**RE: Presbyterian Hospital Site Improvements
100 Central SE
Grading and Drainage Plan
Engineer's Stamp Date: 7/31/19
Hydrology File: K15D005**

Based on the submittal received on 8/7/19, the Grading and Drainage Plan cannot be approved until the following corrections are made:

PRESBYTERIAN HOSPITAL
SITE IMPROVEMENTS
1100 Central Avenue SE
Albuquerque, NM 87106

**GRADING &
DRAINAGE PLAN**

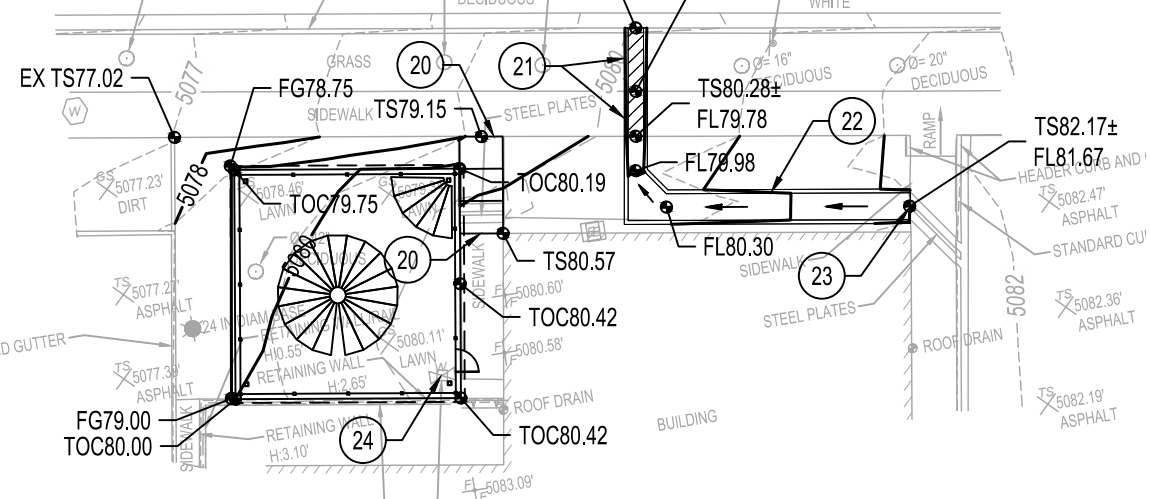
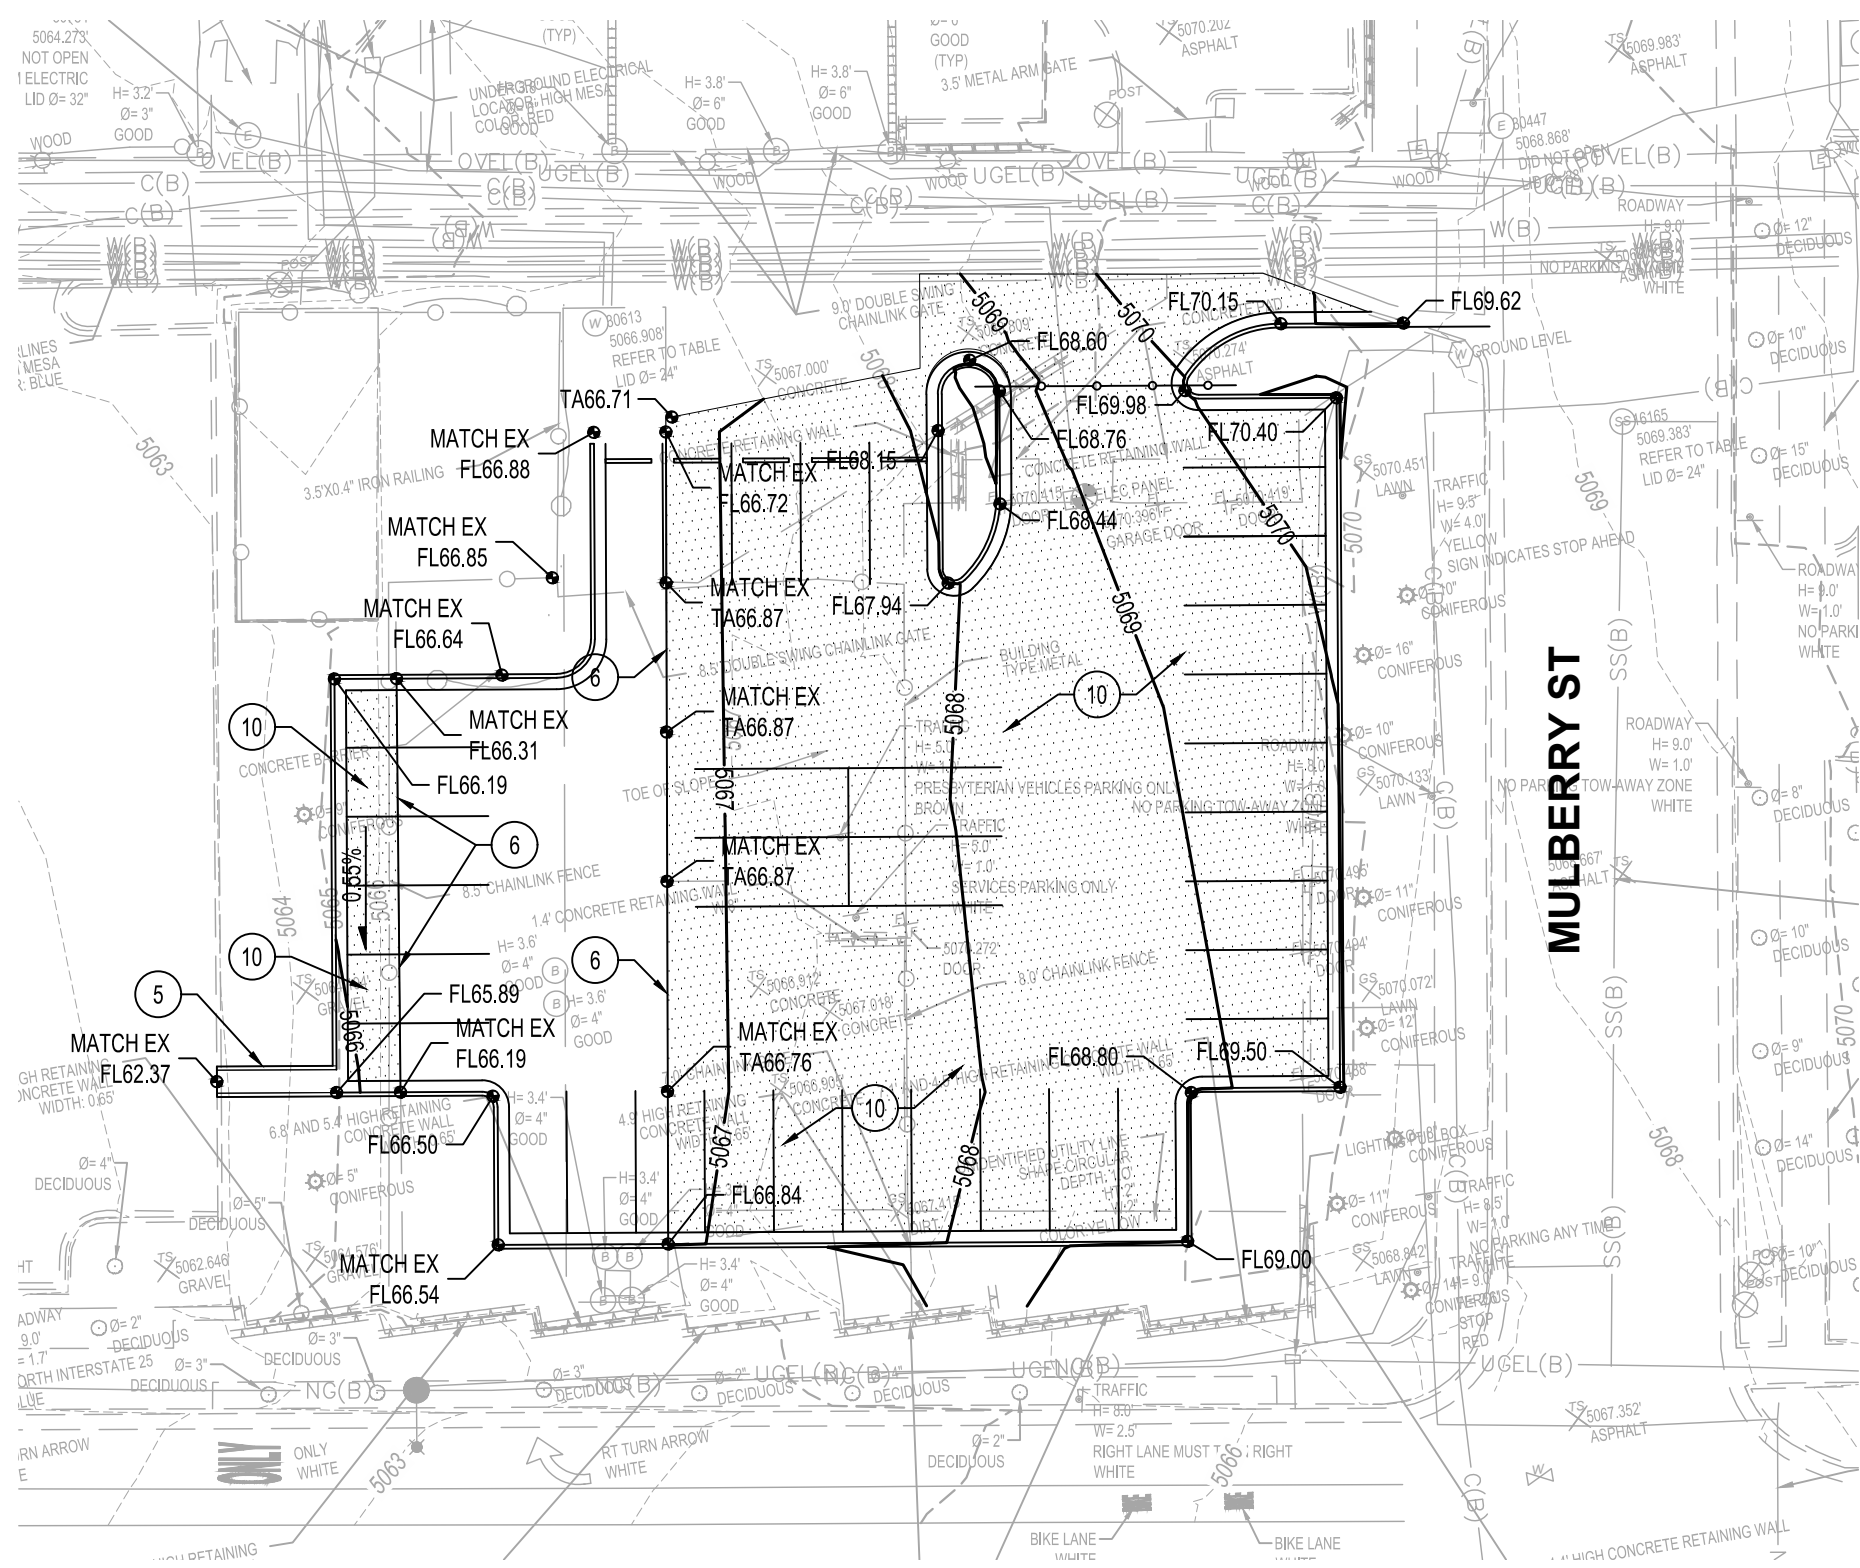
1. This project requires a Master (conceptual) Grading and Drainage Plan that encompasses the entire plan of development that can be included in the Site Plan.

2. Provide project phasing as needed and assign this portion an appropriate phase number/name.
3. Each portion of the project (viewport) needs to include the street names.

4. Screenback or turn-off the extraneous survey layers.
5. Please use the most recent [standard SO-19](#) notes on the grading plan and callout the work to be performed by SO-19 Permit. If a Work Order is required than the SO-19 work will have to be performed by Work Order, not SO-19.

6. Provide management onsite for the Stormwater Quality Volume (SWQV) in accordance with the new drainage ordinance, § 14-5-2-6 (H) enacted 10/2/18 (Council Bill C/S O-18-2). You may elect to make Payment-in-Lieu of onsite management for the volume not captured. In order to pursue this, the plan must state that: you could provide onsite management, you do not want to (due to cost or convenience), and you are electing to make the Payment in Lieu of onsite management.

7. This site qualifies as redevelopment and is only required to retain runoff from the 80th percentile storm (Vol. = 0.26''*Imp.Area).

8. Include project benchmark and datum; all existing survey, proposed grades, and benchmarks must be provided in NAVD 88.
9. Payment in Lieu (Amount = TBD) of onsite management of the SWQV must be made.
10. Hydraulic calculations per the DPM Ch.22.3 are required for all sidewalk culverts, swales, storm drain, etc...
11. As a reminder, if the project total area of disturbance (including the staging area and any work within the adjacent Right-of-Way) is 1 acre or more, then an Erosion and Sediment Control (ESC) Plan and Owner's certified Notice of Intent (NOI) is required to be submitted to the Stormwater Quality Engineer (Doug Hughes, PE, dhughes@cabq.gov, 924-3420) 14 days prior to any earth disturbance.
